Access Compliance Report

Public Rights-of-Way

Intersection ID: 17742	Main Street: S_WENDOVER_RD	Cross Street: PROVIDENCE_RD	Location: NE
ADA ID: 4A0AAF17CD3F	Ramp Type: PerpDiag	Initial Pass/Fail: Fail	Overall Compliance: No
Severity Score: 21.25			
Codes/Mitigation Info/Possible Solution		Field Measurements/Component Compliance

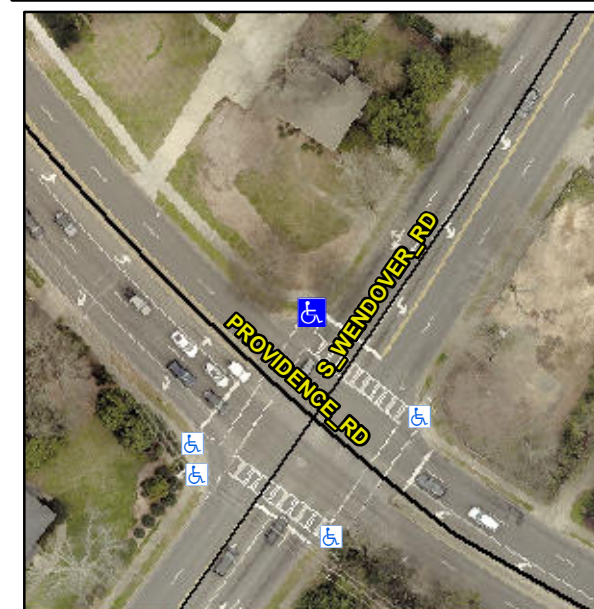
Not Found, R304.5.1, R304.2.2

Compliance	Description	Data	Compliance	Description	Data
N/A	Ramp Length (in)	47.0	No	Ramp Slope (%)	11.7
No	Ramp Width (in)	42.0	Yes	Ramp XSlope (%)	0.9
N/A	Flare Type LT	N/A	N/A	Flare Type RT	N/A
N/A	Flare Slope LT (%)	N/A	N/A	Flare Slope RT (%)	N/A
N/A	Flare Traversable LT?	N/A	N/A	Flare Traversable RT?	N/A
N/A	Landing Length (in)	N/A	N/A	DWS Provided?	N/A
N/A	Landing Width (in)	N/A	N/A	DWS Contrast?	N/A
N/A	Landing Slope (%)	N/A	N/A	DWS Length (in)	N/A
N/A	Landing X Slope (%)	N/A	N/A	DWS Full Width?	N/A
N/A	Landing Curb? (Y/N)	N/A	N/A	DWS Offset (in)	N/A
N/A	Shared Landing?	N/A			
N/A	Gutter Ponding?	N/A	N/A	Gutter Slope (%)	N/A
N/A	Gutter Lip Ht (in)	N/A	N/A	Gutter X Slope (%)	N/A
N/A	Painted X Walk1?	Yes	N/A	Painted X Walk2?	Yes
	X Walk 1 Direction	To SW		X Walk 2 Direction	To SE
N/A	X Walk 1 Width (in)	103.0	N/A	X Walk 2 Width (in)	102.0
	X Walk 1 Slope (%)	0.1		X Walk 2 Slope (%)	4.2
	X Walk 1 X Slope (%)	2.3		X Walk 2 X Slope (%)	0.6

Remove & Replace Curb Ramp With Two New Directional Ramps or Equivalent. Restripe Crosswalk.
